CITY OF ALBUQUERQUE

RE: Tierra Morena Subdivision, (C-20/D033)
Engineers Certification for Release of Financial Guaranty
Engineers Stamp dated 06/18/2004
Engineers Certification dated 4/25/2007

Re: Tierra Morena Subdivision Drainage Report
Engineer's Stamp dated 6-18-04 (C20/D33)

RE: *QUAIL CREEK SUBDIVISION (C20-D33). GRADING AND DRAINAGE PLAN FOR PRELIMINARY PLAT APPROVAL, SITE DEVELOPMENT PLAN FOR SUBDIVISION AND BUILDING PERMIT APPROVALS. ENGINEER'S STAMP DATED NOVEMBER 30, 2001.*

STORM SEWER & SURFACE FLOW EXHIBIT

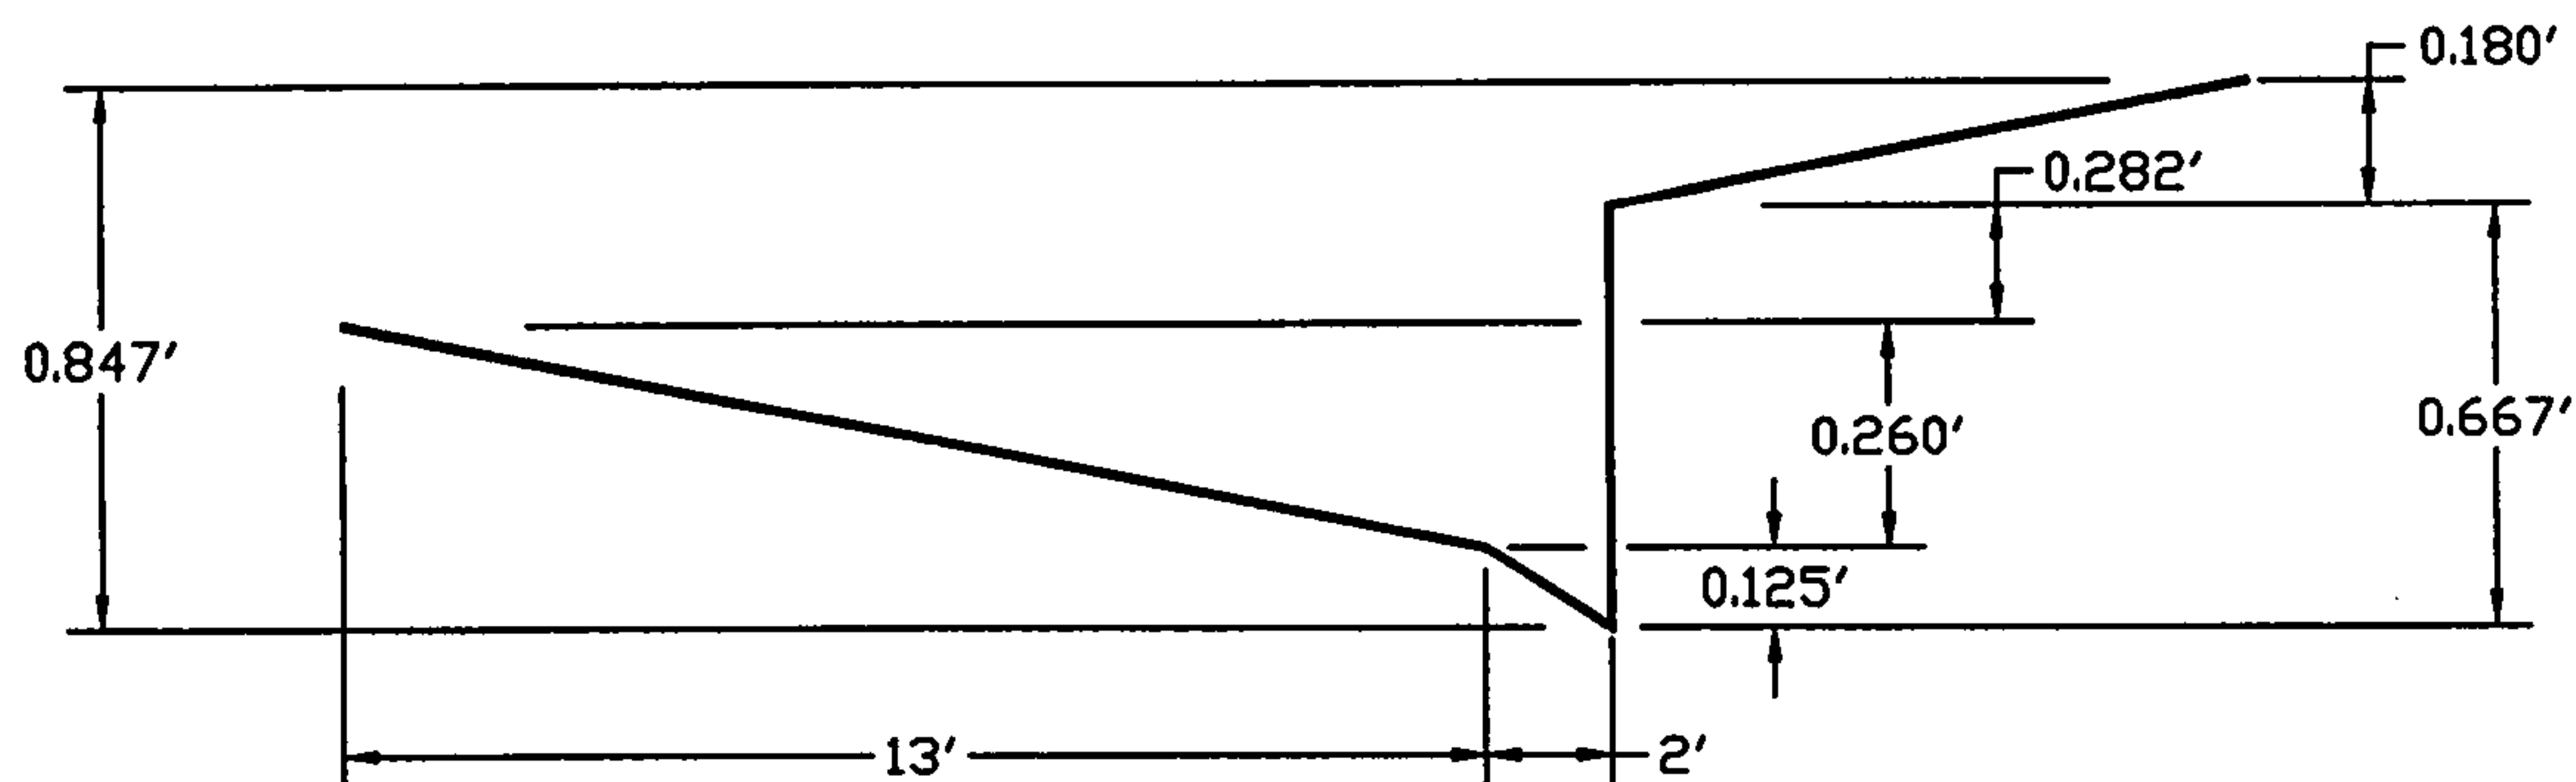
2. Additional inlets have been added on signal to intercept a total runoff of 28.90 cfs. The existing 24" RCP on Barstow does not have adequate capacity to handle the entire 43.28 cfs. See attached exhibit and capacity calculations for the 24" RCP. The 28.90 cfs along with the runoff from the subdivision located on the southeast corner of Signal Ave. and Barstow (18 cfs) will total to a runoff of 46.90 cfs. The capacity of the pipe at MH-A is only 40.20 cfs. We are assuming that the additional flow will not impact the capacity of the 24" RCP, since the MH is located at the downstream of the 24" RCP and may drain the runoff from Ashton Pl. prior to arrival of the runoff from upstream. Also, the inlet at the west end of Ashton is in a sump conditions, and it has adequate ponding capacity incase the runoff would back up into the storm pipe. The remaining runoff from Signal Ave. (14.38 cfs) along with the runoff from Barstow (3.17 cfs) will drain south on Barstow via surface at a flow rate of 17.55 cfs. This runoff will be intercepted by the existing inlets on Barstow. Barstow has more than enough runoff capacity (runoff capacity of 99.40 cfs) to handle the runoff of 17.55 cfs.
